Rezoning Transportation Analysis

Petition Number 2016-016 Updated

Location Approximately 4.3 acres located on the northwest corner at the intersection of

North Davidson and East 26th Street

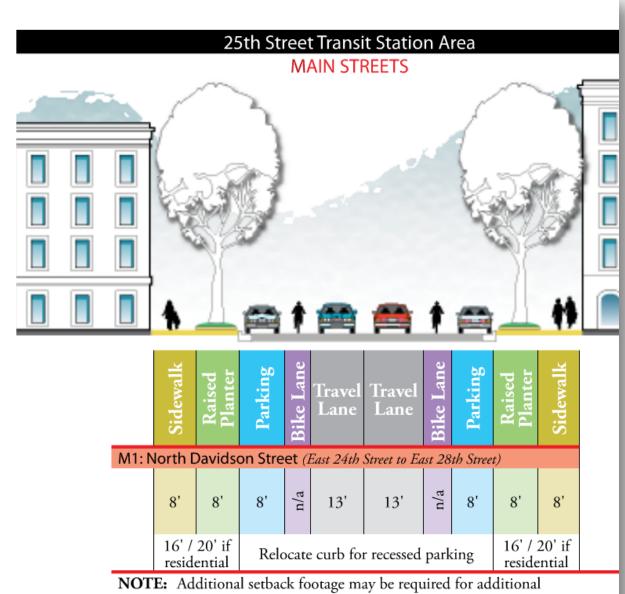
- 2. The Petitioner needs to revise the site plan to depict and reserve right-of-way for the planned Cross Charlotte trail (XCLT) project. The City's XCLT team has recently reviewed the trail's proposed alignment and right-of-way needs with the petitioner/developer (see below exhibit showing XCLT proposed alignment).
